DESIGN REVIEW COMMITTEE MEETING

DESIGN REVIEW COMMITTEE STAFF REPORT

2128 Oxford Street FINAL DESIGN REVIEW

To: City of Berkeley
From: Rhoades Planning Group
Date: December 2, 2024
Re: DRCP2022-0014: 2128 OXFORD STREET - Responses to Preliminary Design Review Comments

5 SECTION DETAIL
A6-3 / SCALE: 1 1/2" = 1'-0"

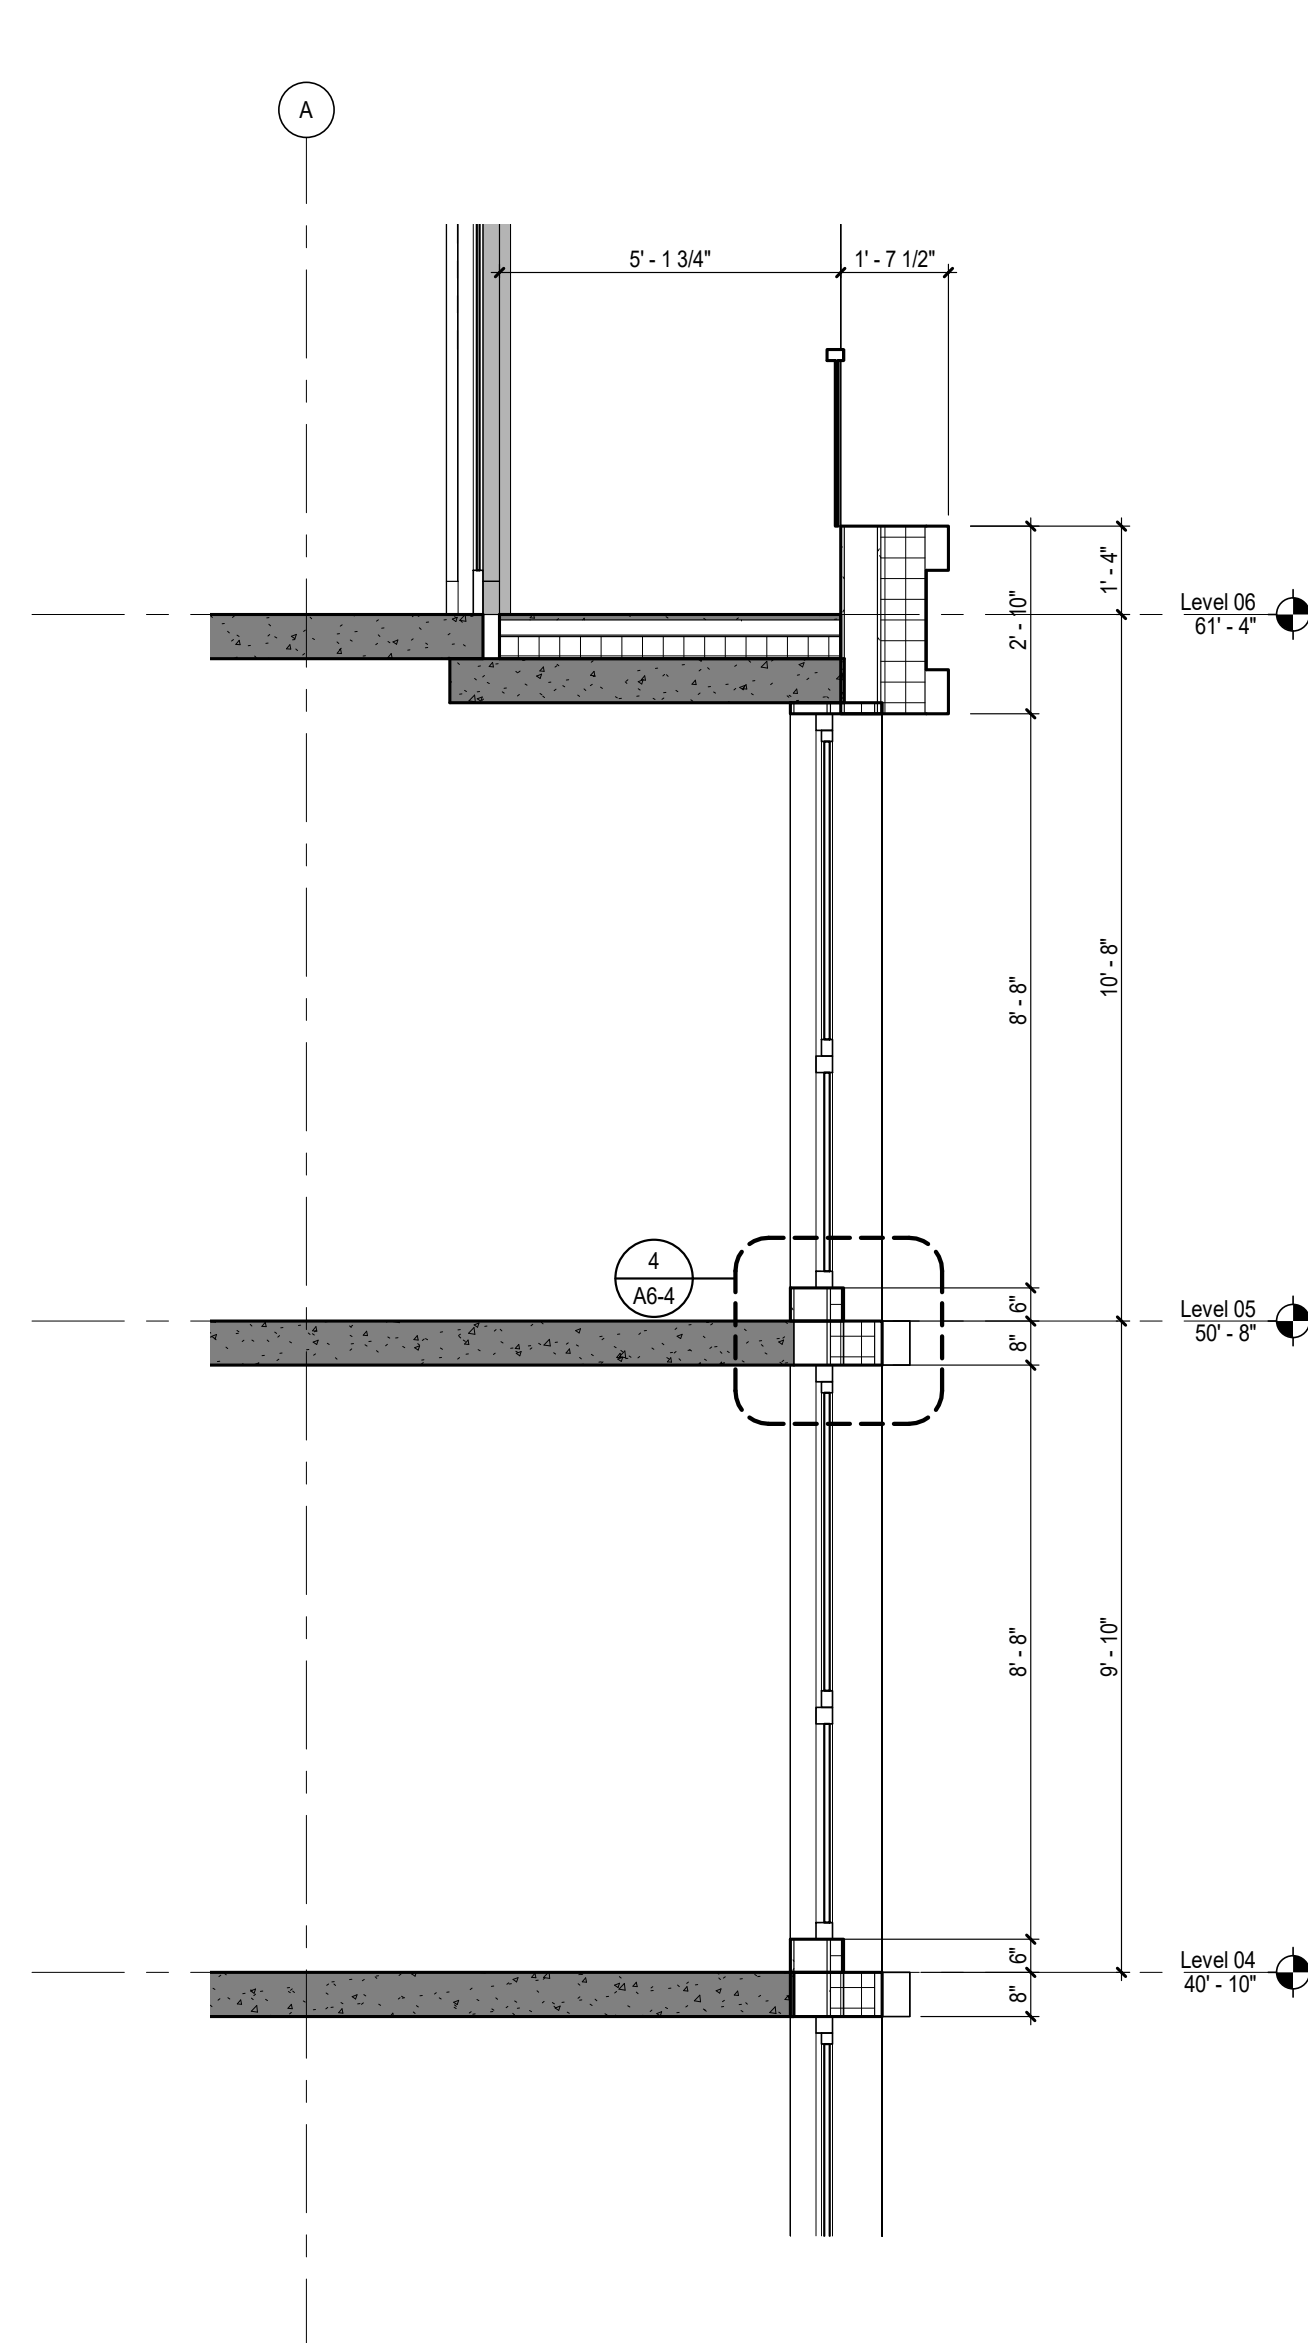
3. Consider more shadow lines and detail on the lighter masses proposed; shadow lines should be deeper, as the building is so large. Shallow ones will not have enough impact.	The façade has depths of 2" and 4" to work within the insulation thicknesses, while creating opportunities for shadow lines. See sheet A6-3.

4 SECTION DETAIL
A6-5 / SCALE: 1 1/2" = 1'-0"

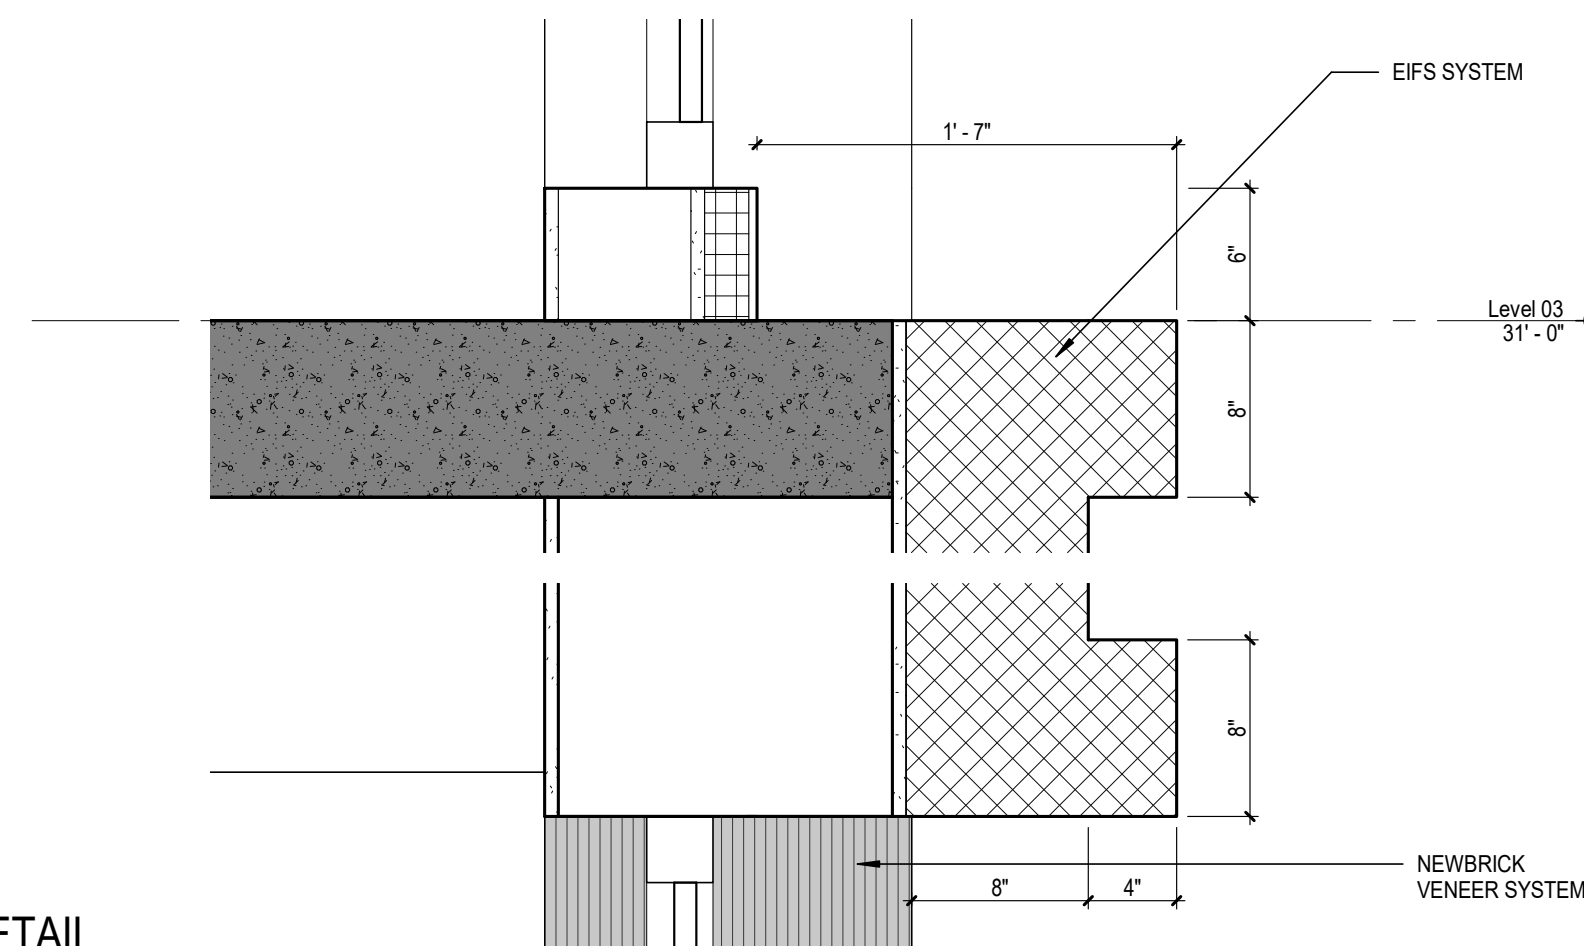
4. Provide more pedestrian detail for storefronts on Center; consider additional detail, base, and an additional rhythm in the design.	The team has increased the base/bulkhead height with black granite and added a sill profile and steel profile at the storefront head to add more detail at storefronts. See façade details on Sheet A6-5.
